CALL NO. 200
CONTRACT ID NO.
131212 Addendum # 2

Subject: Marshall Trigg County, 121GR13D012 - NHPP 0801 (098)
Letting December 20, 2013

- (1) Revised - Plan Sheets - R2, S2, S134, S183, S184A, S184B, S187, S192, S194, S206, S207, S207A, S207B, S208, S208A, S208B, S209, S209A, S210, S211, S212, S213, S216, S217, S260, S261, S274
- (2) Revised - Cover Page - PAGE 1 of 403
- (3) Revised - Completion Dates - Page 4 of 403
- (4) Revised - Multiple Notes - Various Pages
- (5) Revised - Bid Items - Page 397-403 of 403
- (6) Delete - Pages 27thru44, 216thru233, 207thru215, 234thru238 of 403

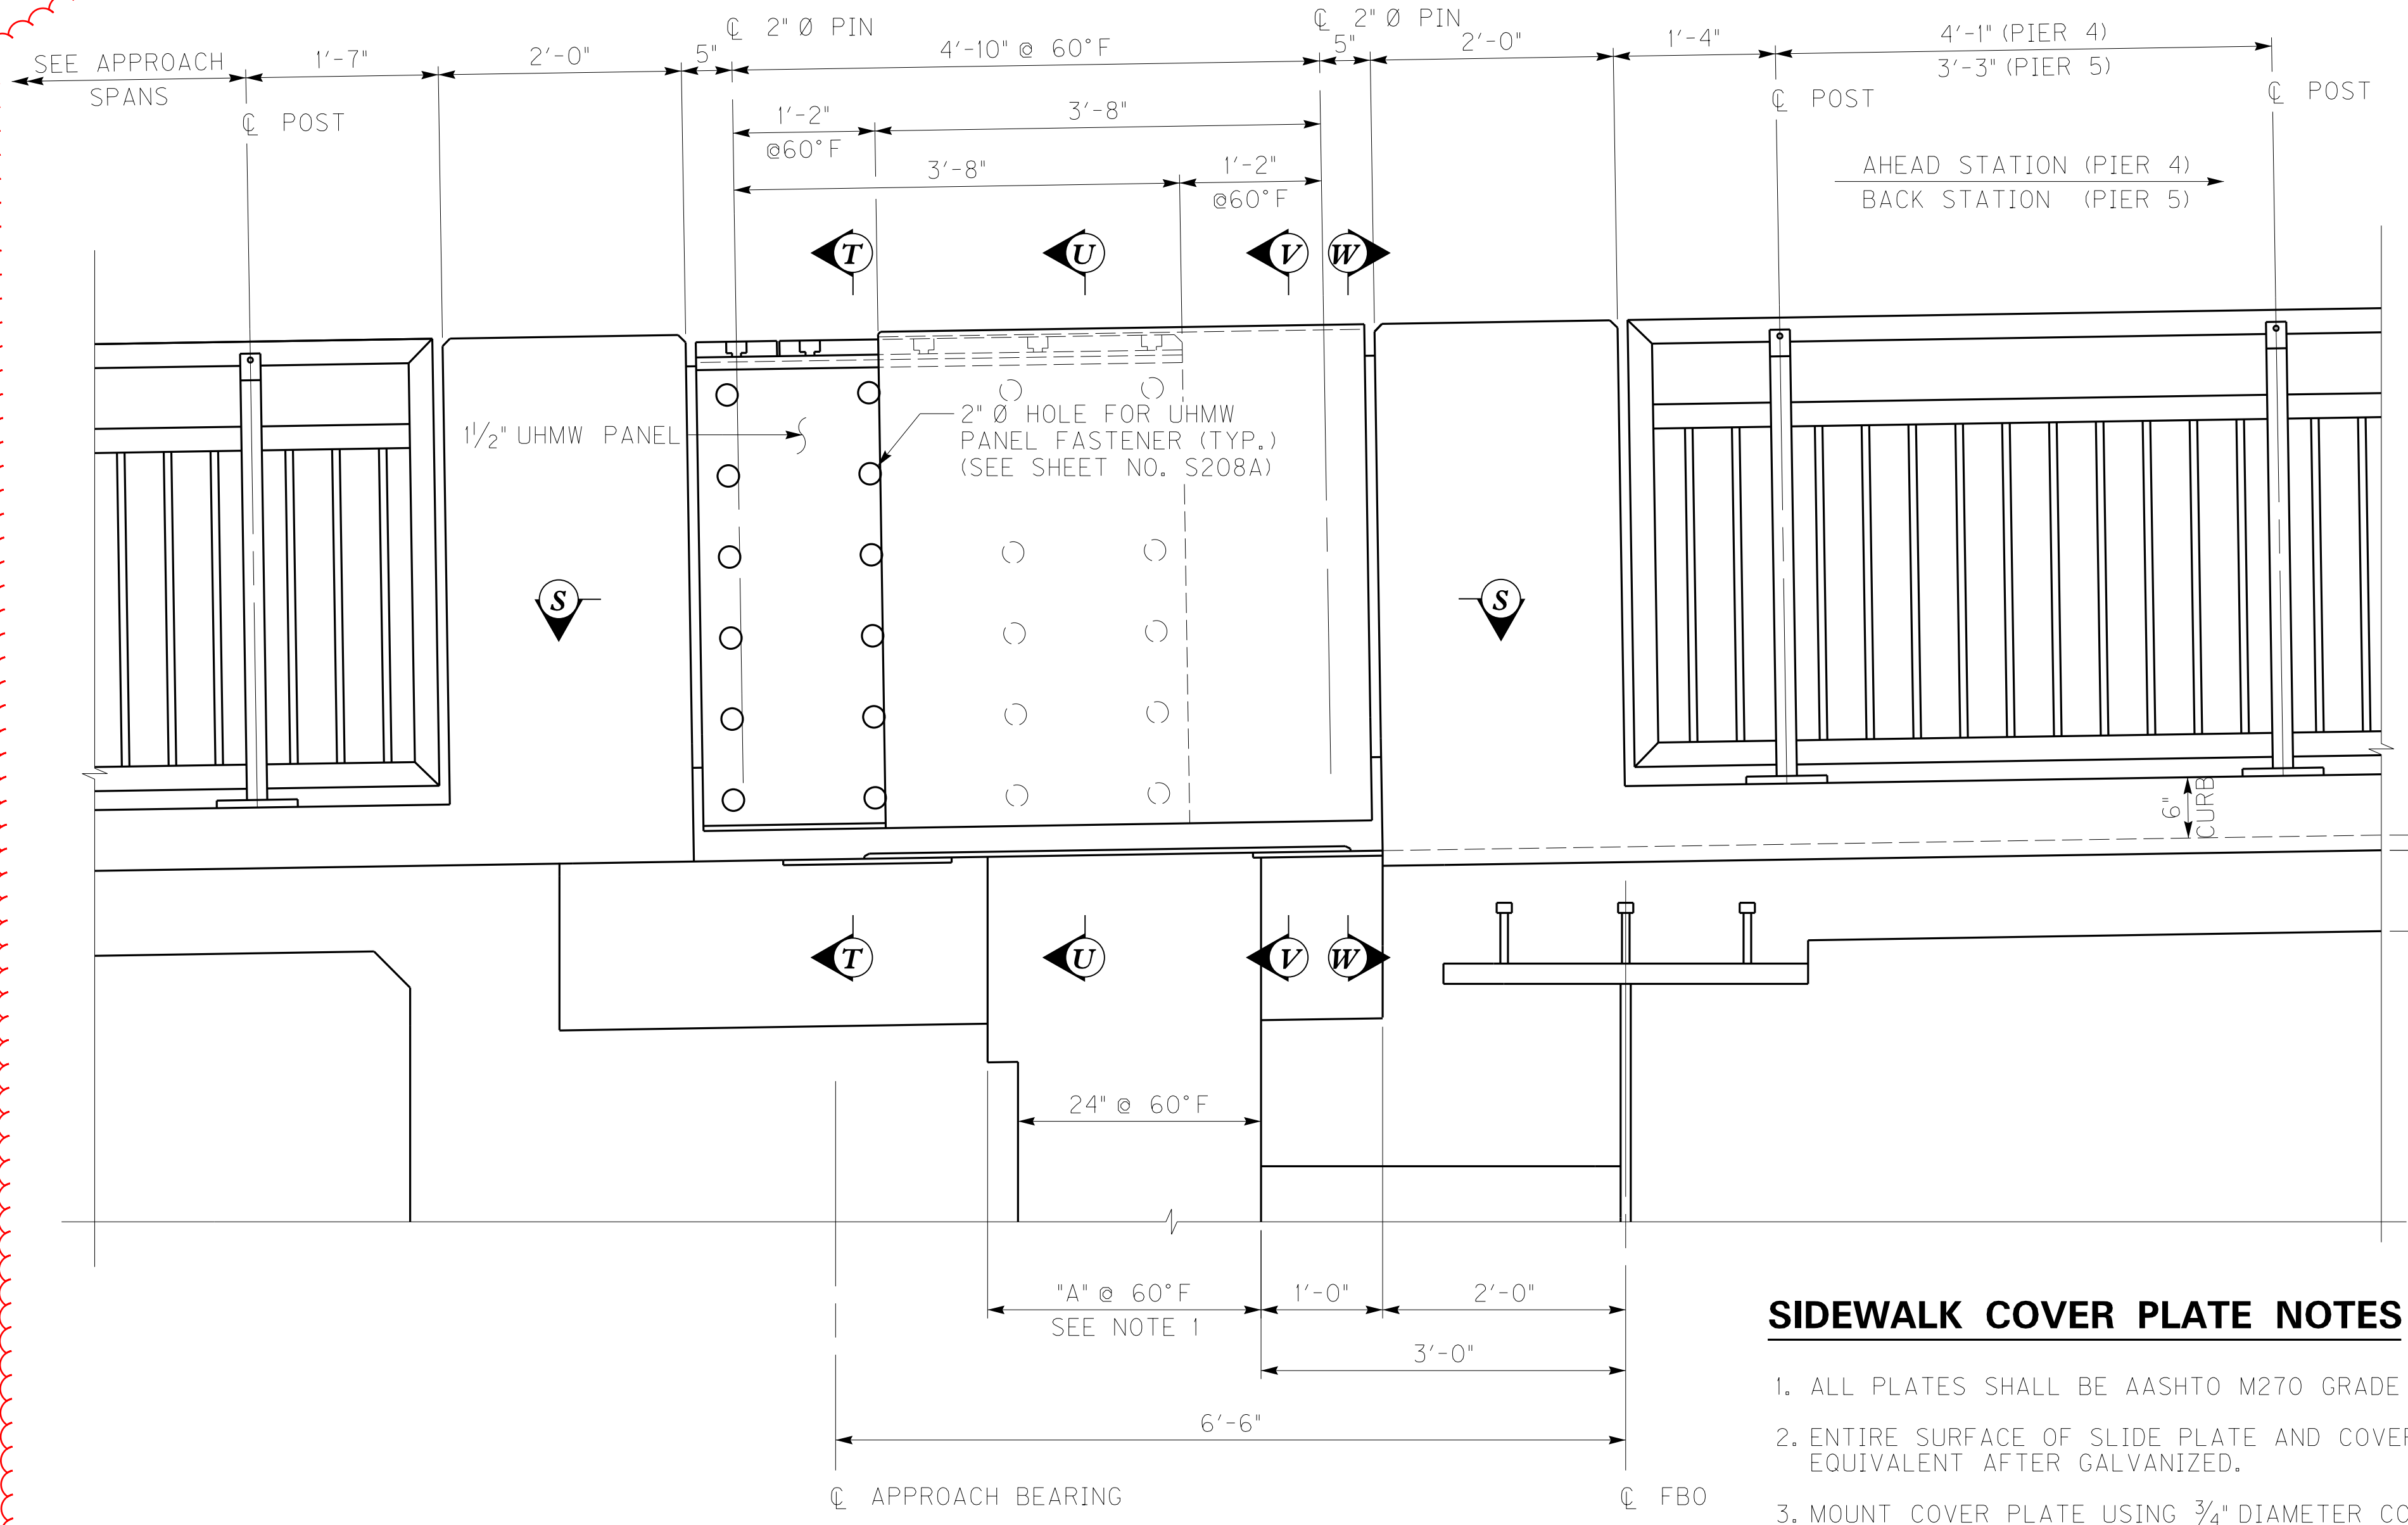
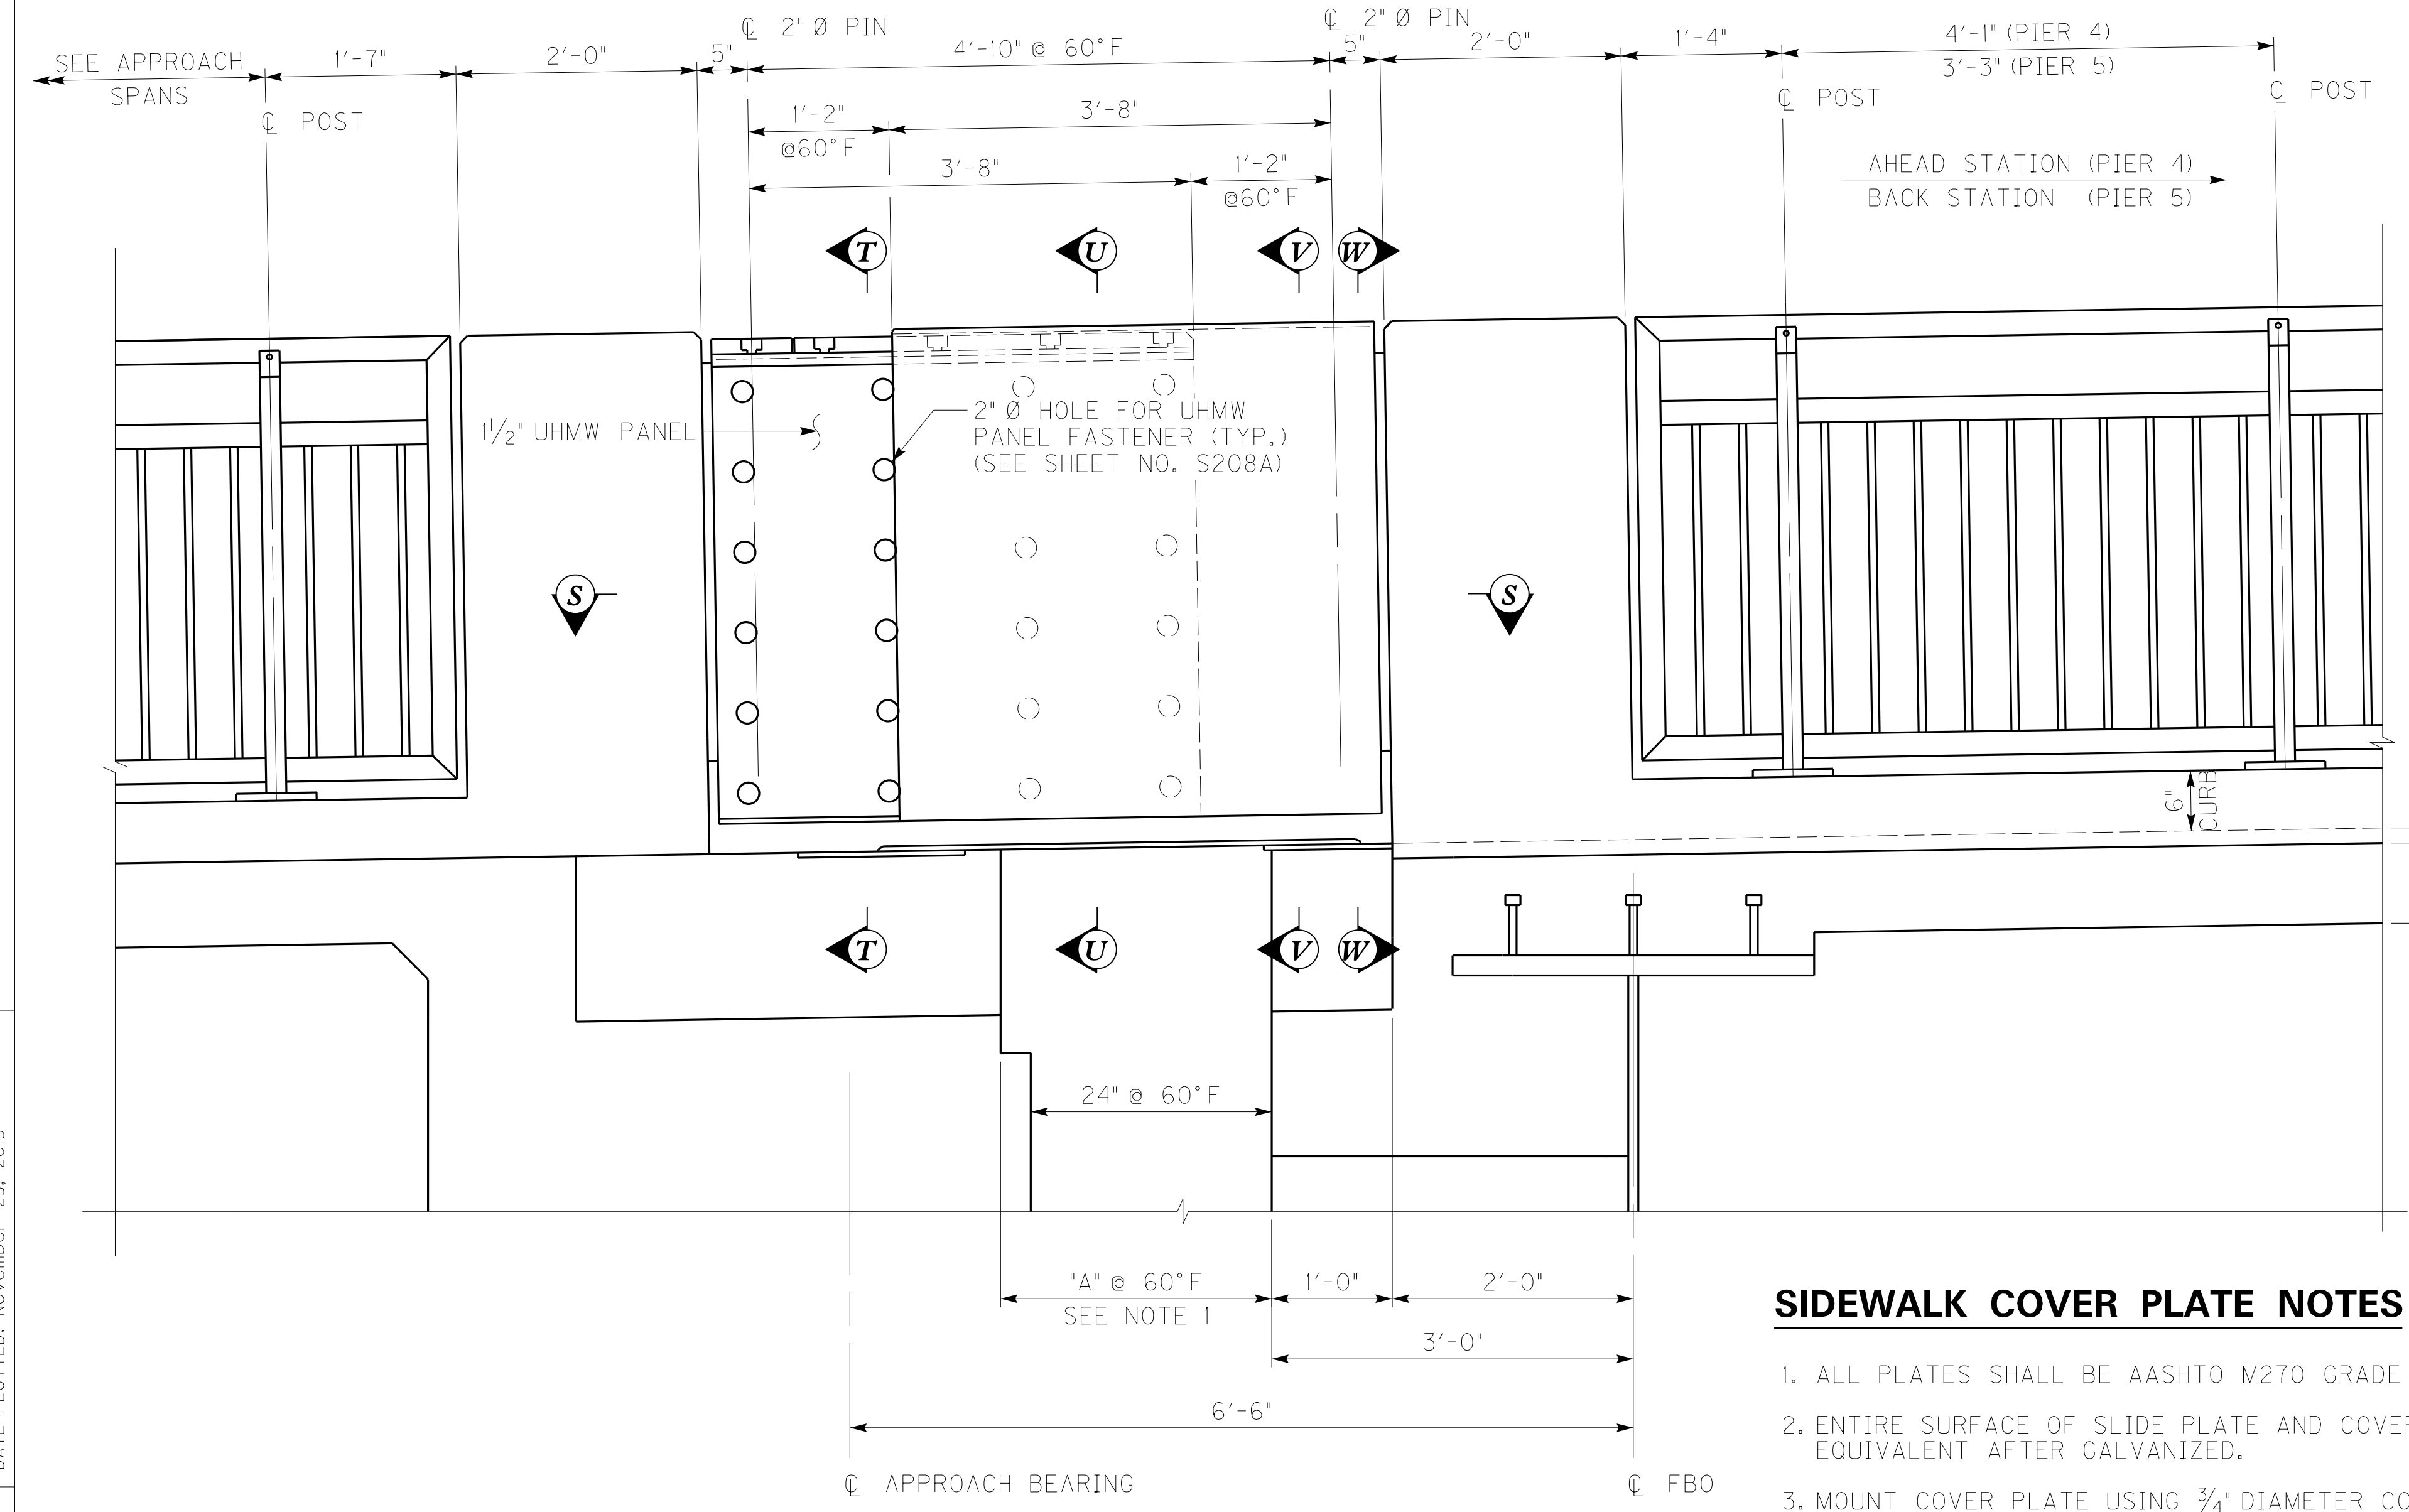
REVISION		DATE
Δ REVISED SHEET		11/25/13
DATE: NOVEMBER 15, 2013	DESIGNED BY: DMB	CHECKED BY: TJT
DESIGNED BY: DMB	DESIGNED BY: MJD	CHECKED BY: DMB
Commonwealth of Kentucky DEPARTMENT OF HIGHWAYS		
COUNTY MARSHALL / TRIGG		
ROUTE US68	CROSSING KENTUCKY LAKE	
MODULAR EXP. JOINT DETAILS - 7		
ITEM NUMBER 01-180.70	PREPARED BY Baker	SHEET NO. S209 DRAWING NO. 24686
